M60/M62/M66 Simister Island Interchange

TR010064

7.24 WRITTEN SUBMISSIONS FOLLOWING NOVEMBER HEARINGS AND RESPONSES TO ACTION POINTS FROM CAH1 AND ISH2

**WRITTEN SUBMISSIONS FOLLOWING NOVEMBER HEARINGS AND
RESPONSES TO ACTION POINTS FROM CAH1 AND ISH2**

Drawing title
INDIVIDUAL LAND PLOT PLAN
1/1a

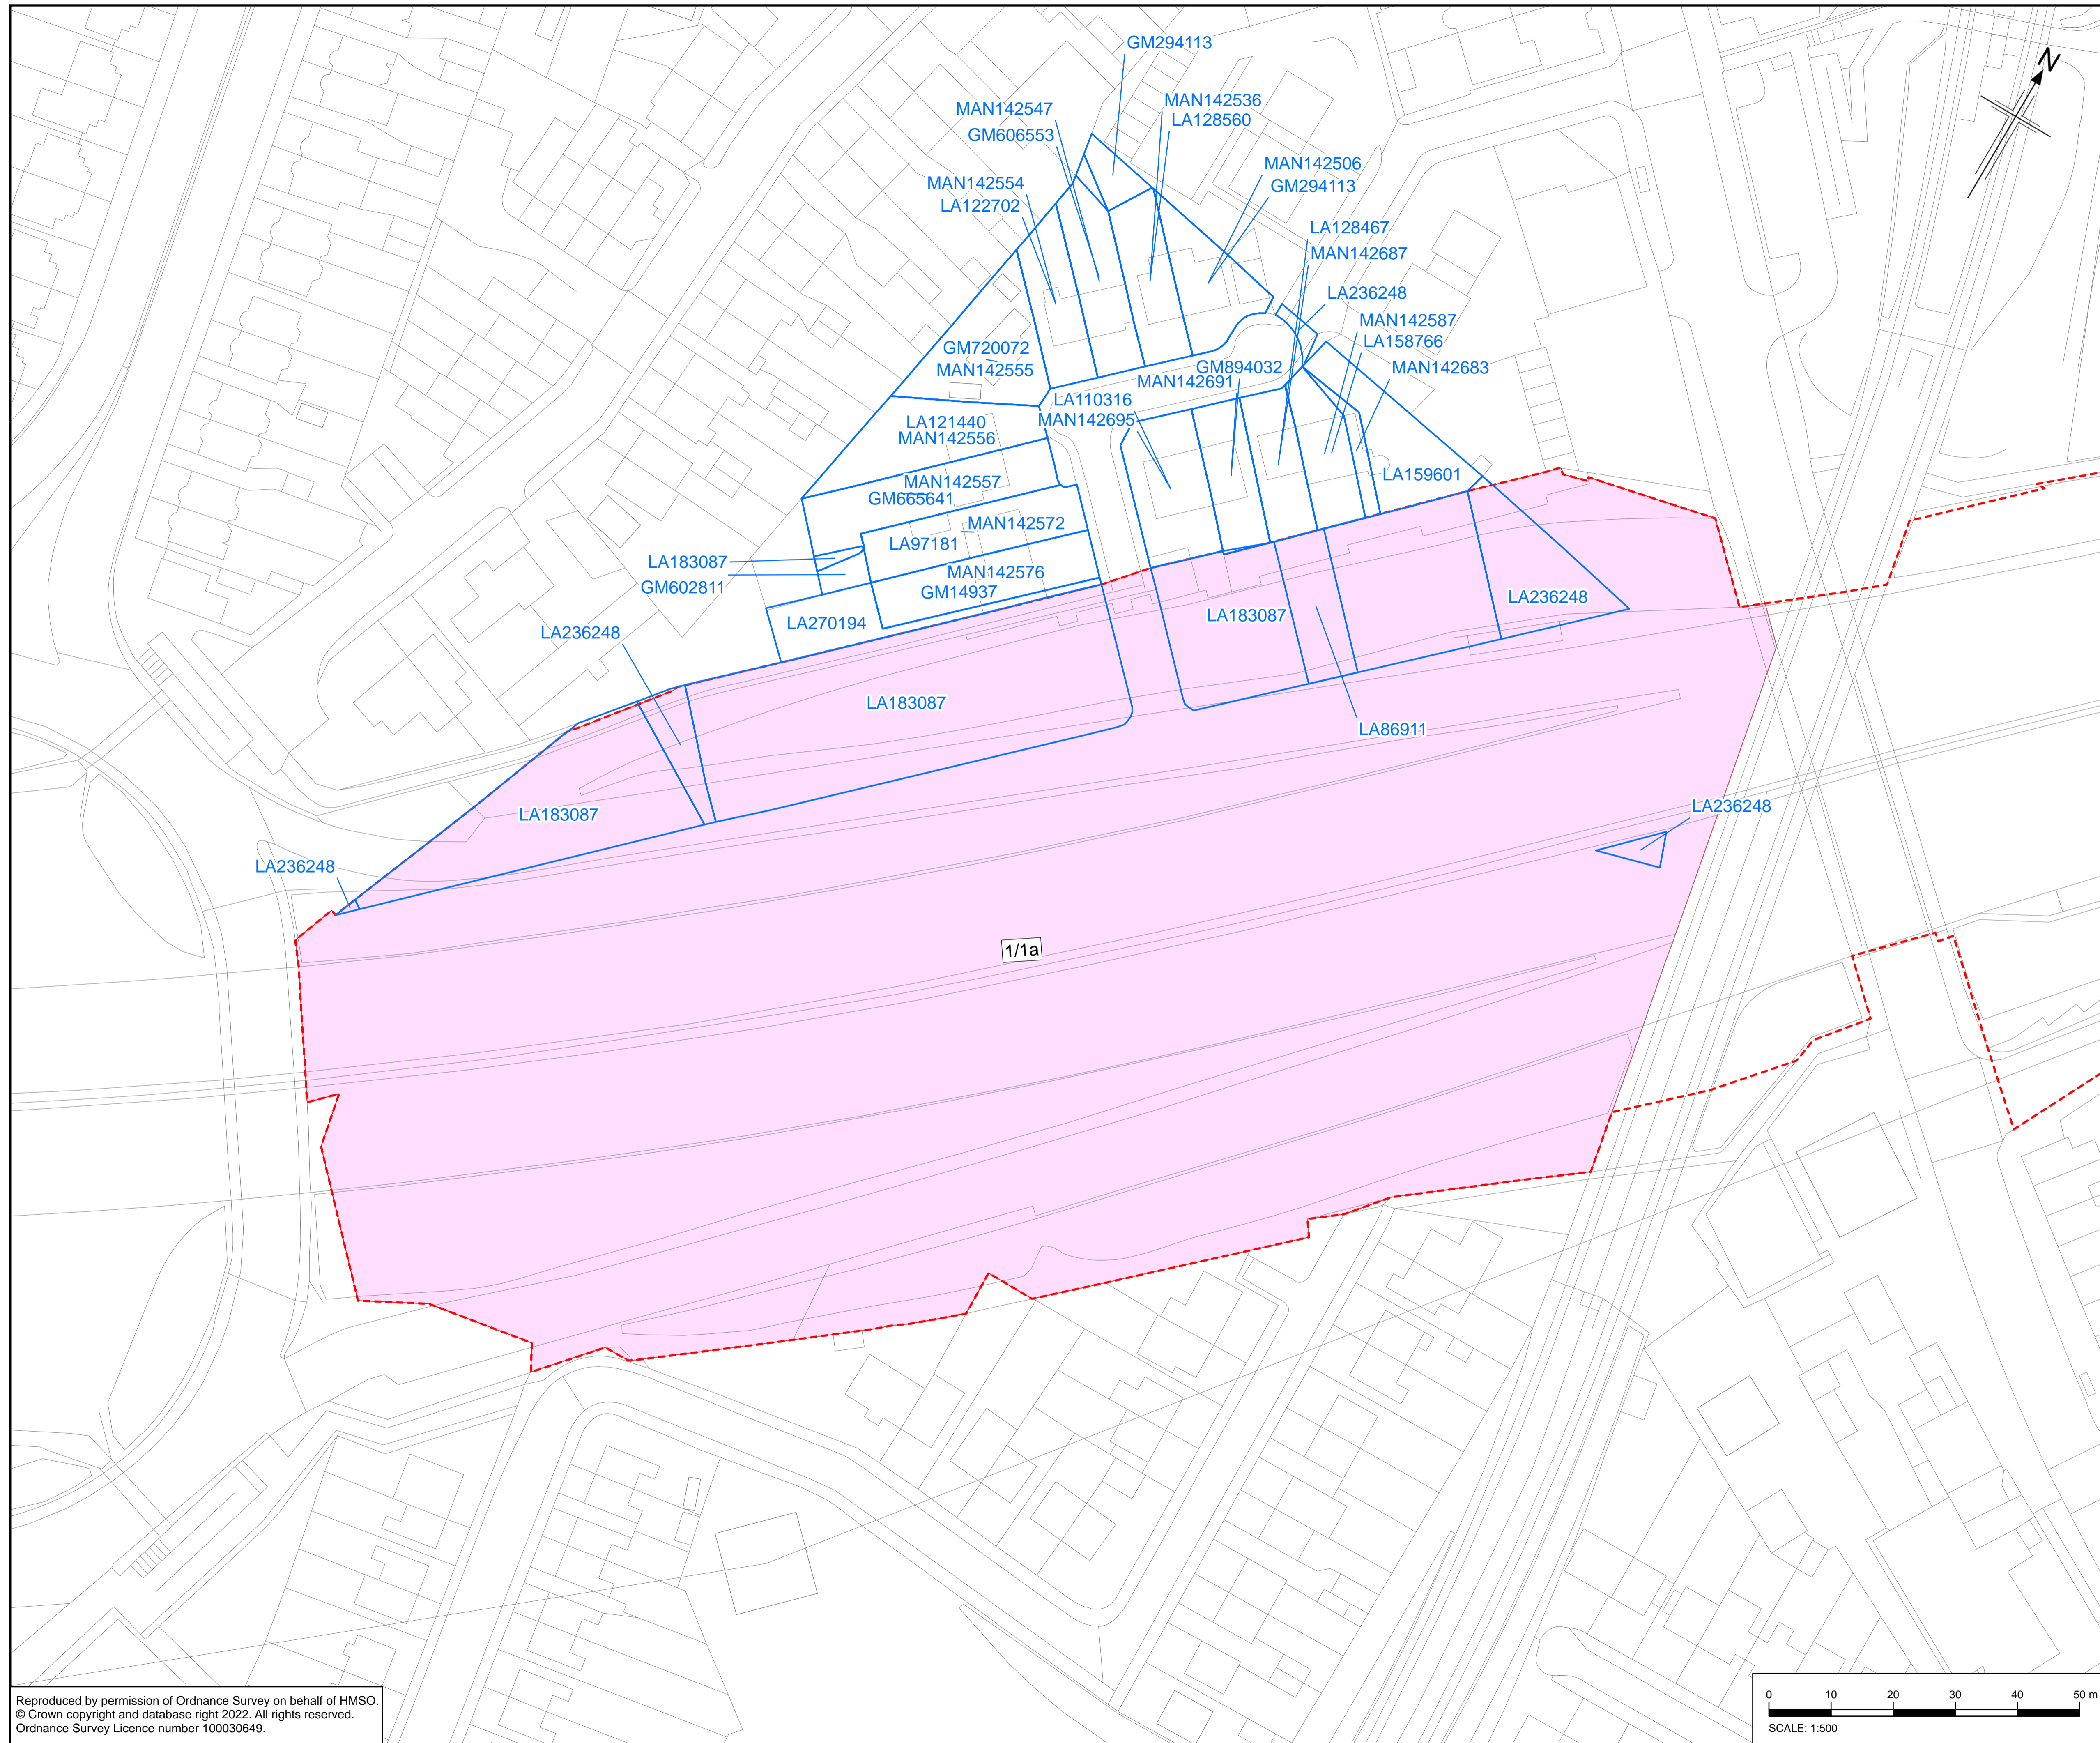
CAH1-4	Review plans in respect of Plot 1/1a and the extent of land illustrated to be acquired on the plans in comparison to that listed in the Book of Reference [REP3-008].	Applicant	D4	<p>The area of Plot 1/1a within the Order Limits is owned by the Applicant. Historically, and prior to the construction of the M60, the boundary of Plot 1/1a corresponded to the northern boundary of properties immediately adjacent to "Yorkshire Road".</p>  <p>The Applicant, when it was the Highways Agency, acquired properties in this area. As a result, the Order Limits now appear to extend into residential properties that were previously adjacent to Yorkshire Road. Please see plan provided in Annex D for clarity on the title boundaries. Additional titles outside the Order limits have been shown on the plan to provide context.</p>
CAH1-5	Supply further details to explain why Plots 2/1aw and 2/1av are required to deliver the scheme.	Applicant	D4	The Applicant confirms that Plots 2/1aw and 2/1av comprise part of the private road known as Egypt Lane. The plots are within the freehold ownership of the Applicant. The Applicant requires the ability to pass and repass over Egypt Lane in order to undertake the Scheme. Whilst the Applicant can pass and repass over its own land, Plots 2/1aw and 2/1av are subject to other third-party Category 1 and 2 interests as identified in the Book of Reference [REP03-

Action	Description	Action by	When	Applicant Response & Summary of Action taken
				008]. To ensure that the Applicant can use Egypt Lane without constraint from any third-party interests, it has erred on the side of caution and included its own land as being subject to compulsory acquisition. This approach is consistent with the approach generally adopted by the Applicant in respect of the compulsory acquisition of its own land. It is also consistent with the approach adopted on other made DCOs.
CAH1-6	Consider whether provision could be added to the draft Development Consent Order (dDCO) to more precisely restrict the time limit required to temporarily possess gardens located adjacent to the M60 to the minimum time necessary.	Applicant	D5	
CAH1-7	Consider whether provision could be added to the dDCO to more precisely restrict the time limit required to temporarily possess Plots 1/5aq and 1/5as to the minimum time necessary.	Applicant	D5
